HISTORIC AND DESIGN REVIEW COMMISSION

November 02, 2016

HDRC CASE NO: 2016-430
ADDRESS: 163 SCHREINER PLACE
LEGAL DESCRIPTION: NCB 7053 BLK LOT 16 AND E25 FT OF 15
ZONING: R-5
CITY COUNCIL DIST.: 1
DISTRICT: Monte Vista Historic District
APPLICANT: Patrick Shearer
OWNER: Name Shearer, Patrick Shearer
TYPE OF WORK: Install driveway
REQUEST:

The applicant is requesting a Certificate of Appropriateness for approval to install a 10' wide parking pad made of square concrete pavers with grass in between.

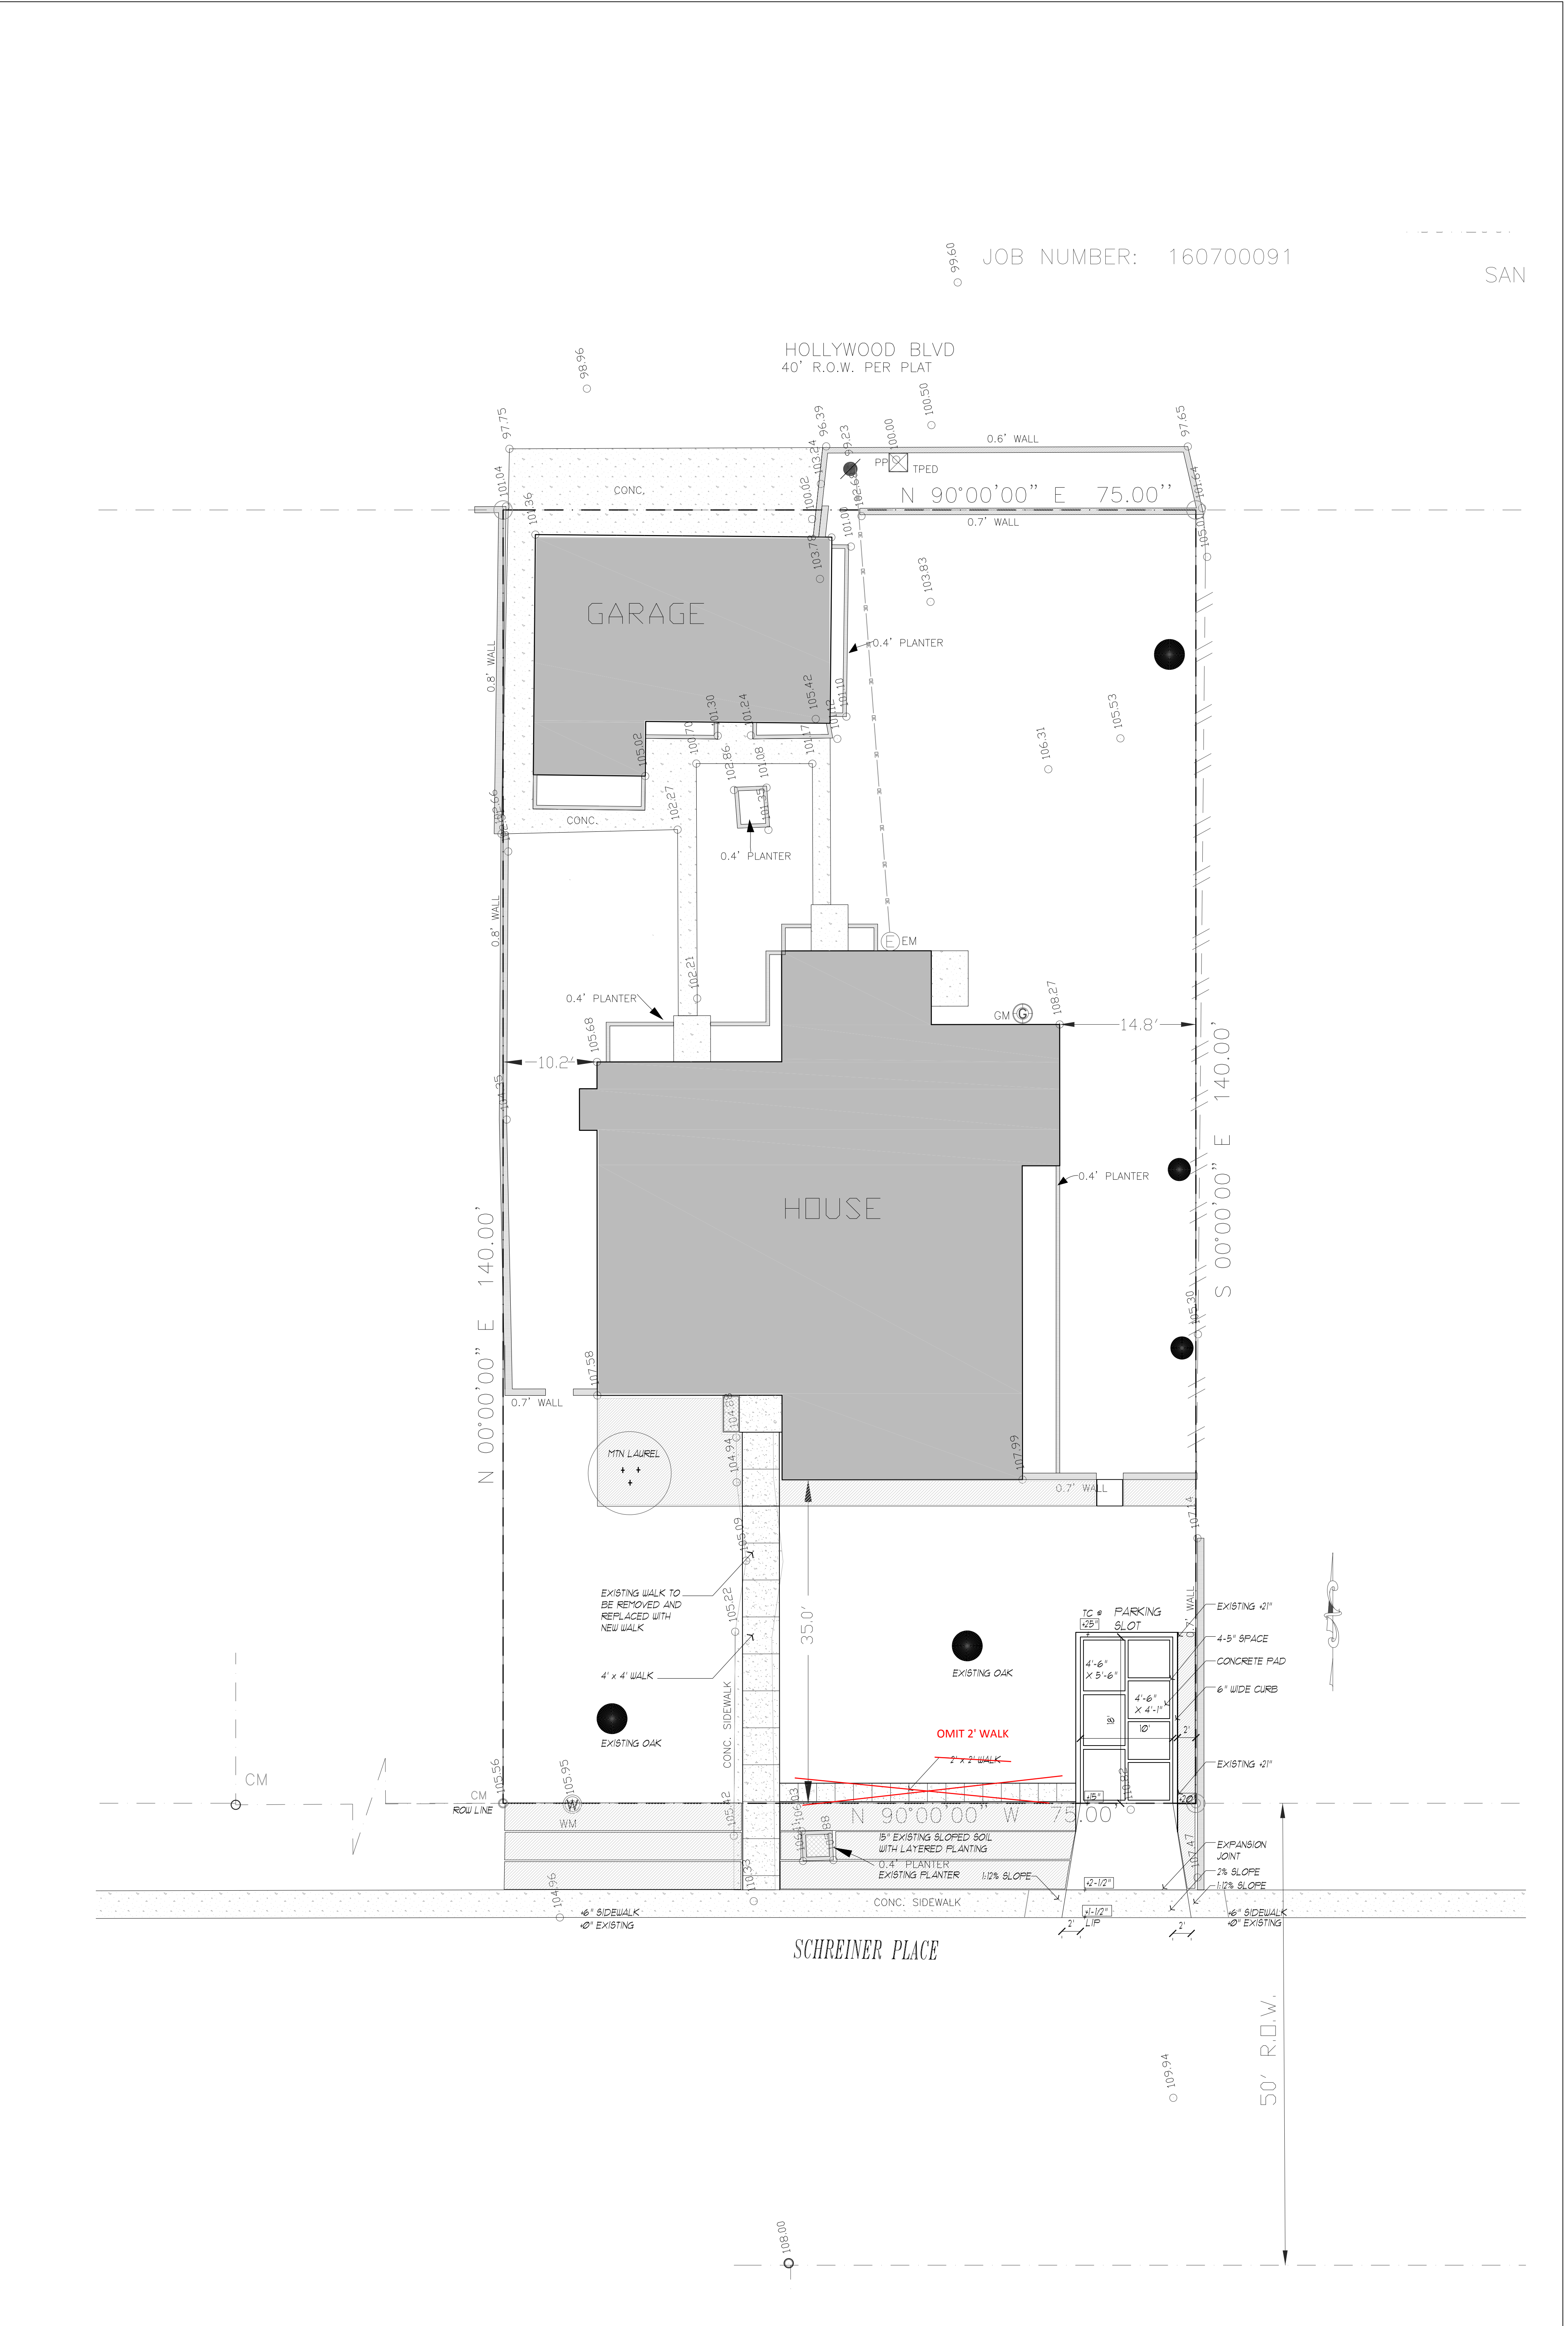
- b. There is no existing driveway or parking in the front. There is an existing rear garage that is accessed from Hollywood Boulevard. The applicant is proposing to install a 10' wide concrete parking pad in the front yard with access from Schreiner Place. The pad will have 6" wide curb on the left, rear and right side of the proposed pad. The pad configuration is made of 7 salt finished concrete pavers. According to the Guidelines for Site Elements 5.B.i., new driveways should incorporate a similar configuration to those found in the district. Staff made a site visit on October 21, 2016, and found that there are driveways that access Schreiner Place historically. Staff finds that the configuration of the driveway is not typically found, but finds the modern configuration and width appropriate for the site.

Staff recommends approval of the proposed parking pad based on findings a through b.
